APPLICATION NO.	FILING DATE	FIRST NAMED INVENTOR	ATTORNEY DOCKET NO.	CONFIRMATION NO.
10/537,068	06/01/2005	Wim Van Houtum	NL021308	8817

Office Action Summary	Application No. 10/537,068	Applicant(s) VAN HOUTUM, WIM	
	Examiner KABIR A. TIMORY	Art Unit 2611

DETAILED ACTION

In figure 3 of the instant application the applicant illustrate:

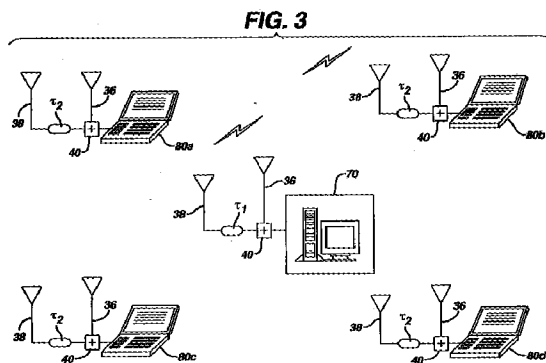
Also on page 5, lines 24-30 of the specification of the instant application, the applicant discloses: ***“At a receiving terminal, the signal power P radiated by the transmitting terminal is received by two antennae 36 and 38, each receiving the total power P radiated by both transmitting antennae. The multiple receiving antenna will therefore improve the signal to noise performance of the system since the total power received by both antennae is $2P$. There is also a***

diversity of receive signal paths, as the RF signal path of the receiving antenna 38 of a mobile terminal exhibits a delay of T_2 while the receiving antenna 36 exhibits a delay of zero".

In figures 2 and 4, Li et al illustrates:

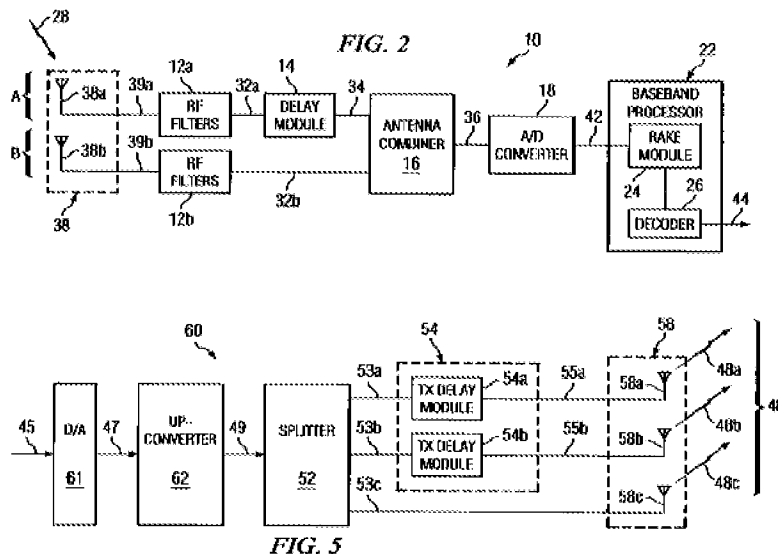
In figure 2 above, Li et al. clearly shows that receive antennas 38a and 38b receive communication signal, where the signal which is received by antenna 38a is delayed by the delay module line 14 (non-zero delay). Figure 2 also shows that the signal which is received by received antenna 38b has no delay module. The delayed and non-delayed signals are combined (added) by the antenna combiner 16. In figure 5 above, Li et al. show that the transmitting antenna 58a also has a TX delay module 54a (non-zero delay), where the other transmitting antenna 58c has no delay module. The systems of figures 2 and 5 of Li et al. have the same operation and arrangement as shown figure 3 of the instant application. Therefore, the examiner makes his broadest reasonable interpretation in light of the specification that the third antenna (38a in figure 2) having a signal path exhibiting a different delay (14 in figure 2) than a signal path of

the fourth antenna (38b in figure 6), wherein a nonzero delay of one of the signal paths of the first and second antennae (58a and 58c in figure 5) is different from a nonzero delay of one of the signal paths of the third and forth antennae (38a and 38b in figure 2).

Thus, it would have been obvious to one ordinary skill in the art at the time the invention was made to use the receive and transmit apparatus as taught by Li et al. to modify the system and method of Sugar et al. in order to generate diversity signals at the receive and transmit antennas (see figure 2 and 5, col 1, lines 42-56, col 3, lines 35-67, col 4, lines 1-54, col 6, lines 42-67, col 7, lines 1-45).

In figure 3 of the instant application the applicant illustrate:

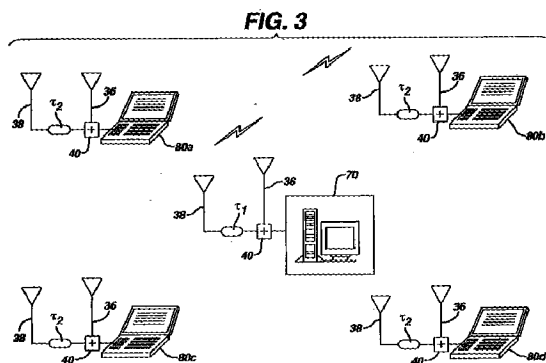
Also on page 5, lines 24-30 of the specification of the instant application, the applicant discloses: ***“At a receiving terminal, the signal power P radiated by the transmitting terminal is received by two antennae 36 and 38, each receiving the total power P radiated by both transmitting antennae. The multiple receiving antenna will therefore improve the signal to noise performance of the system since the total power received by both antennae is $2P$. There is also a diversity of receive signal paths, as the RF signal path of the receiving antenna 38 of a mobile terminal exhibits a delay of T_2 while the receiving antenna 36 exhibits a delay of zero”.***

In figures 2 and 4, Li et al illustrates:

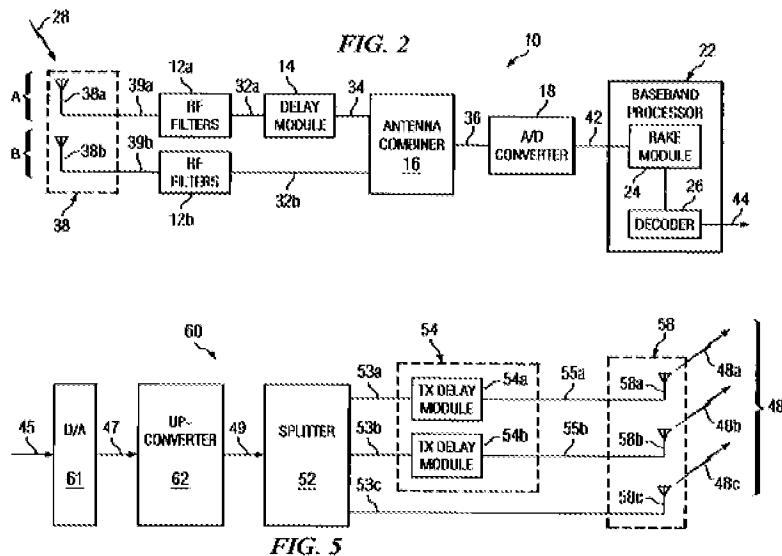
In figure 2 above, Li et al. clearly shows that receive antennas 38a and 38b receive communication signal, where the signal which is received by antenna 38a is delayed by the delay module line 14 (non-zero delay). Figure 2 also shows that the signal which is received by received antenna 38b has no delay module. The delayed and non-delayed signals are combined (added) by the antenna combiner 16. In figure 5 above, Li et al. show that the transmitting antenna 58a also has a TX delay module 54a (non-zero delay), where the other transmitting antenna 58c has no delay module. The systems of figures 2 and 5 of Li et al. have the same operation and arrangement as shown figure 3 of the instant application. Therefore, the examiner makes his broadest reasonable interpretation in light of the specification that the third antenna (38a in figure 2) having a signal path exhibiting a different delay (14 in figure 2) than a signal path of the fourth antenna (38b in figure 6), wherein a nonzero delay of one of the signal paths of the first and second antennae (58a and 58c in figure 5) is different from a nonzero delay of one of the signal paths of the third and forth antennae (38a and 38b in figure 2).

Thus, it would have been obvious to one ordinary skill in the art at the time the invention was made to use the receive and transmit apparatus as taught by Li et al. to modify the system and method of Sugar et al. in order to generate diversity signals at the receive and transmit antennas (see figure 2 and 5, col 1, lines 42-56, col 3, lines 35-67, col 4, lines 1-54, col 6, lines 42-67, col 7, lines 1-45).
